TO USE THE NEW TYPE PLATE INSTEAD OF THE OLD TYPE PLATE YOU NEED TO:

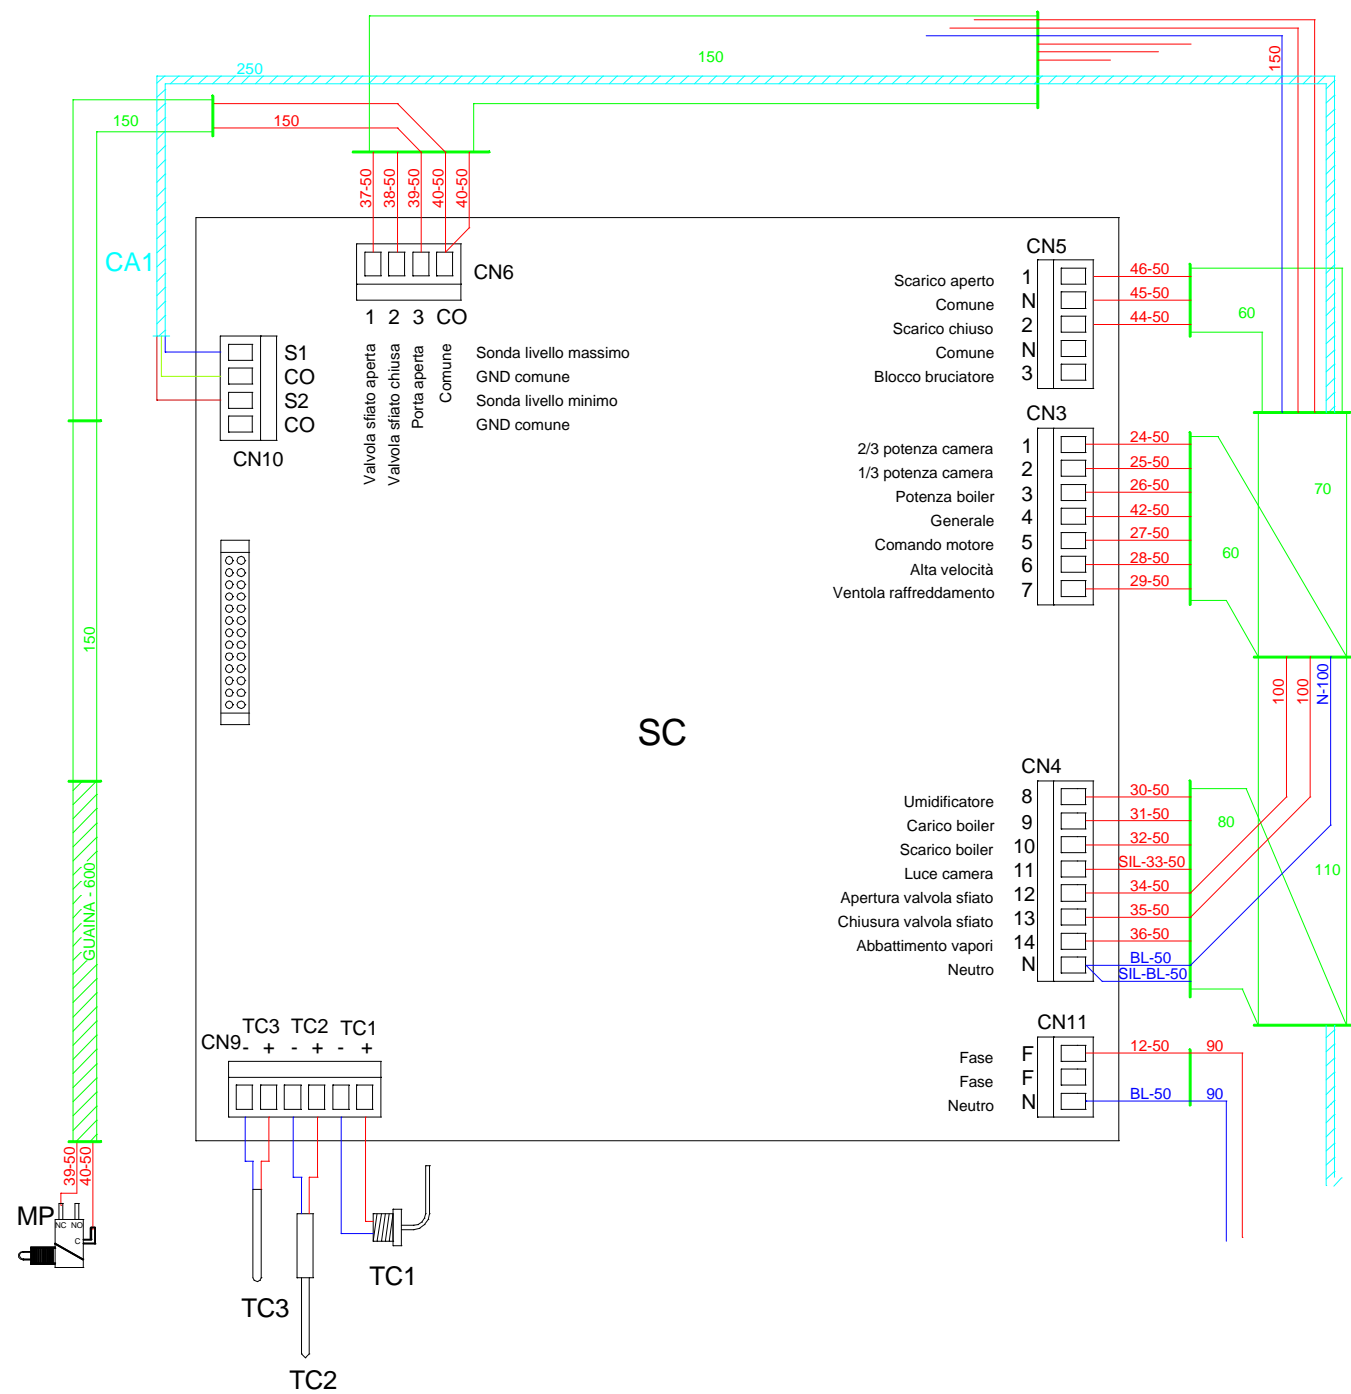
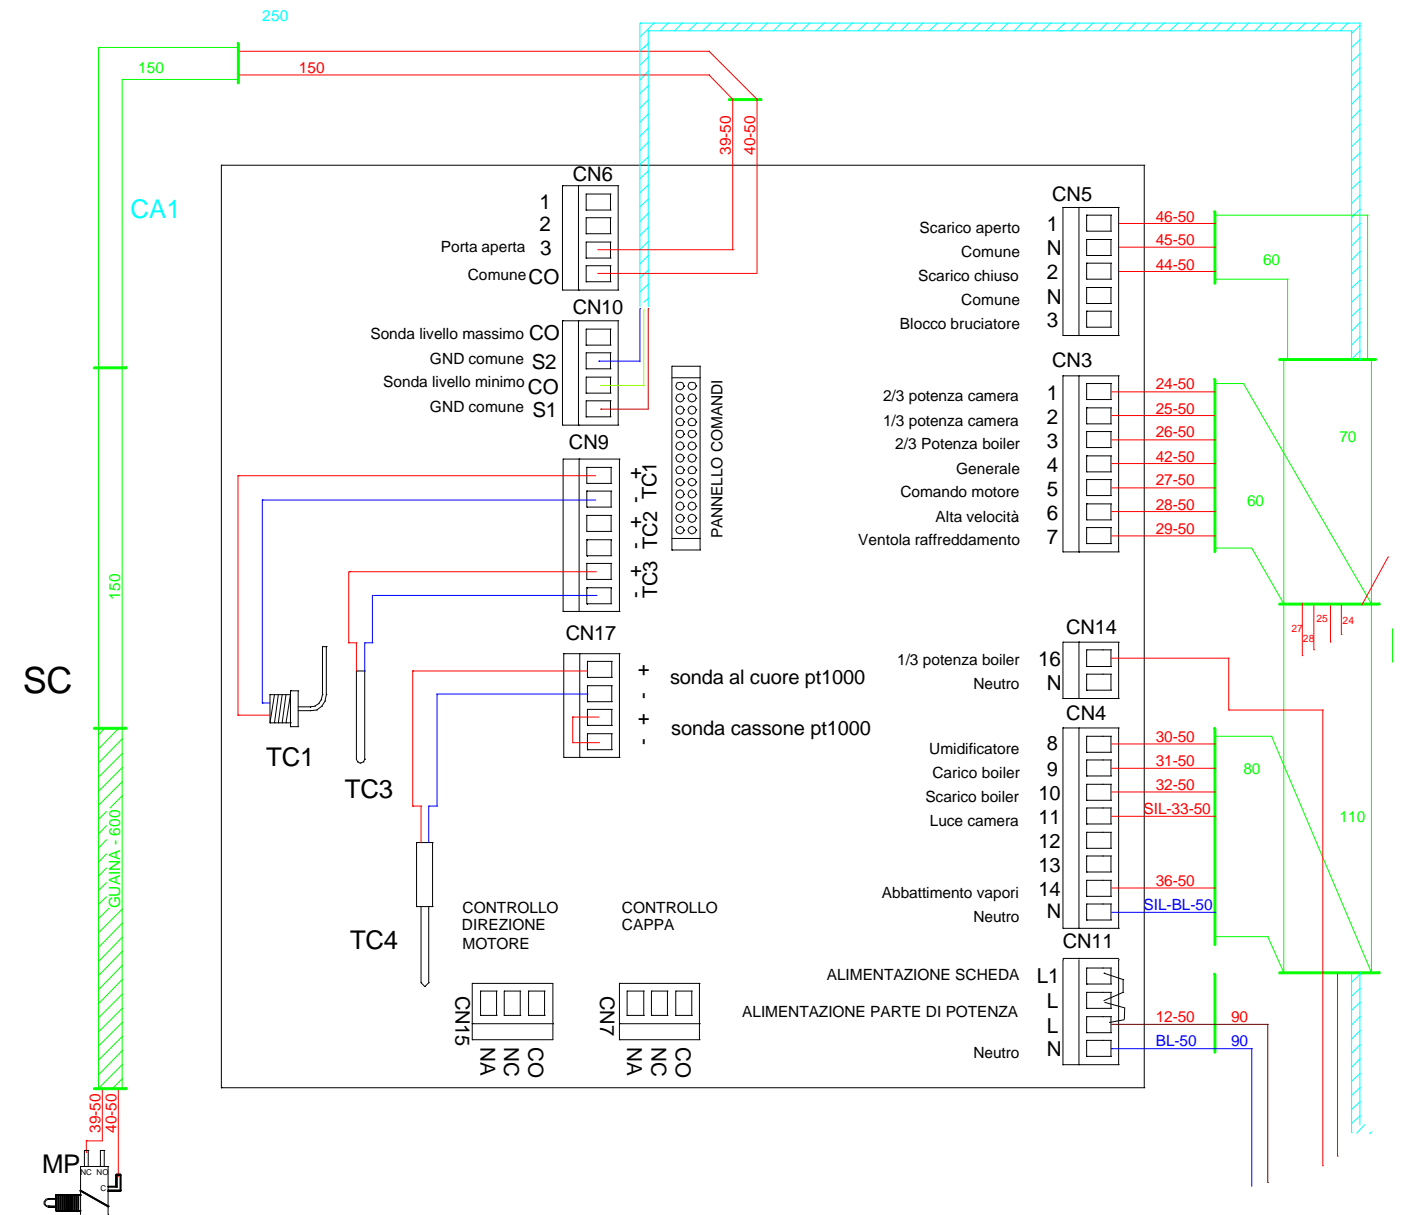
- ADD A BRIDGE ON CONNECTOR CN17 BETWEEN THE "SONDA CASSONE PT1000" PINS (+ -) (INDICATED AS "600 G" ON THE PLATE)
- DOUBLE THE SUPPLY PHASE (WIRE 12) INSTALLING A BRIDGE ON THE CN11 CONNECTOR BETWEEN L1 AND L: CONNECT WIRE 12 ON THE REMAINING L PIN
- THE ORIGINAL CN11 CONNECTOR (3 PINS) MUST BE REPLACED BY A 4 PINS CONNECTOR
- ALL OTHER CONNECTORS REMAIN THE SAME
